06V-087
(9 pages)

Safety Defect and Noncompliance Report Guide for Vehicles
PART 573 Defect and Noncompliance Report¹

SERVICE ADVISORY # 06-067

Raptor Kitchen Slide L.P. Gas Line

Fig. 1

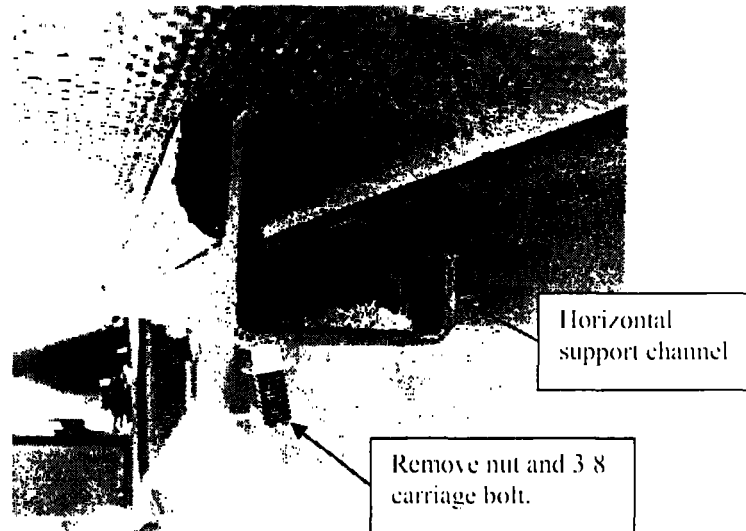
Step 5 Remove the 3/8 x 4" carriage bolts that attach the horizontal support channel to the floor of the slide room (see fig. 1).

Fig. 3

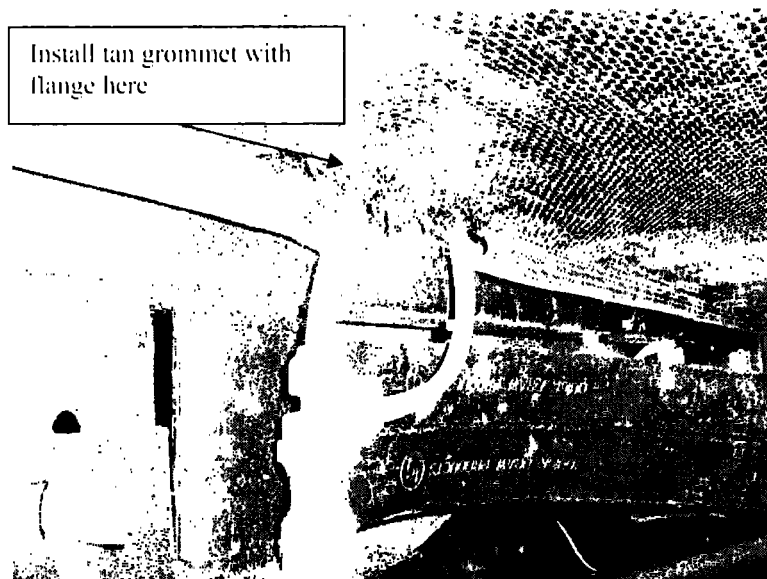
Step 8 Cut a section of 'D' seal out as shown below and drill two 1" holes as close to support channel as possible (see fig 3) and install new copper lines from stove and refrigerator to the connections shown below. Install the pre-made copper line so the tan plastic grommet is on the bottom of the slide room floor. Attach the grommet to the floor with a small screw or staple.

Fig. 4

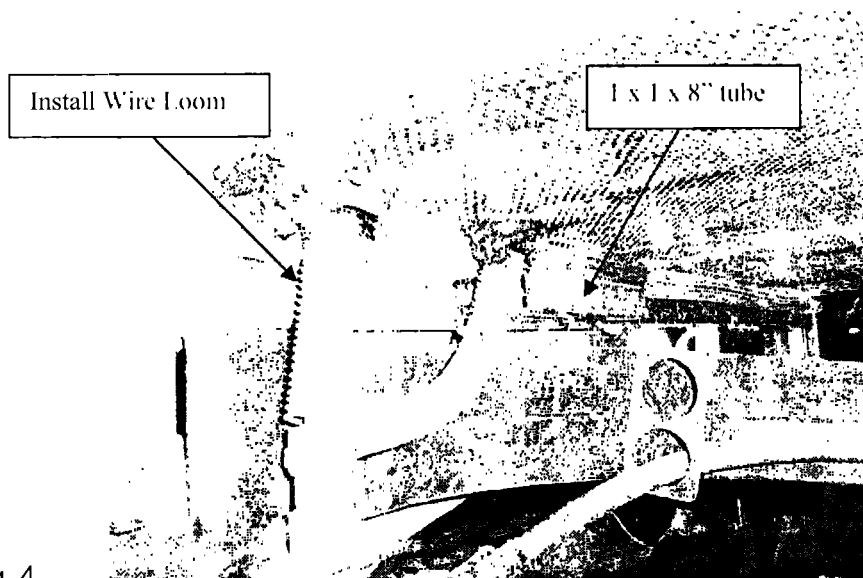
Step 10 Use two ¼ x 1-1/2" self drilling screws to attach a 1" x 1" x 8" steel tube at bottom of support channel as a hard stop between channel and main room floor (see fig 4).

Fig. 5

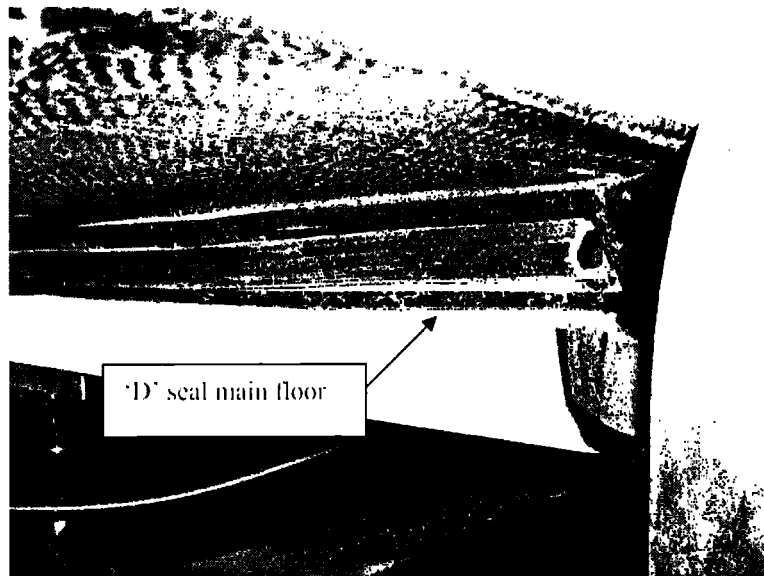
Step 12 Add 'D' seal on edge of main floor as shown (fig 5)
